UNITED STATES PATENT AND TRADEMARK OFFICE

APPLICATION NO.	FILING DATE	FIRST NAMED INVENTOR	ATTORNEY DOCKET NO.	CONFIRMATION NO.
09/876,396	06/07/2001	Syuuichi Kariyazaki	14701	7345

Office Action Summary	Application No.	Applicant(s)	
	09/876,396	KARIYAZAKI, SYUUCHI	
	Examiner Colleen A. Matthews	Art Unit 2811

DETAILED ACTION

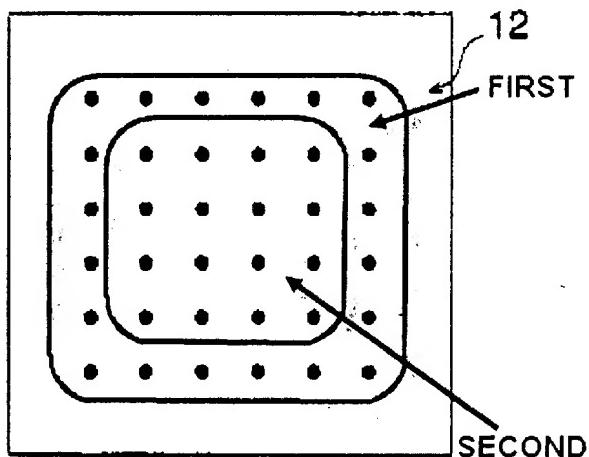
the interconnect pads (12) forming a plurality of I/O cells (shown in Fig 2) including signal terminals, (Col. 3, lines 47 - 57), a portion of the I/O cells forming a first group (FIRST, see annotated figure 2 below) of I/O cells and another portion of the I/O cells forming a second group (SECOND, see annotated figure 2 below) of I/O cells on an inner position of the mounting member with respect to the first group of I/O cells.

Regarding claim 10, Stager et al. teach a semiconductor device, wherein at least one of the first group and the second group includes an outer group and inner group disposed on the inner position of the mounting member with respect to the outer group (Fig. 2).

Applicant argues (Remarks Page 2, Section I) that, contrary to the examiners assertion, that Stager et al.'s interconnection pads are formed with no clear delineation that would lead one skilled in the art to consider the distribution of interconnect pads to be in two groups. The examiner maintains that the interconnect pads of Stagger does meet the claimed limitation "a portion of the I/O cells forming a first group of I/O cells and another portion of the I/O cells forming a second group of I/O cells disposed on an inner position of the mounting member with respect to the first group of I/O cells." Although applicant argues that Stager et al. is not formed with clear delineation of the first and second group of I/O, it does not compromise the fact that one of ordinary skill in the art would be able to interpret Stager et al. to have two groupings of interconnect as
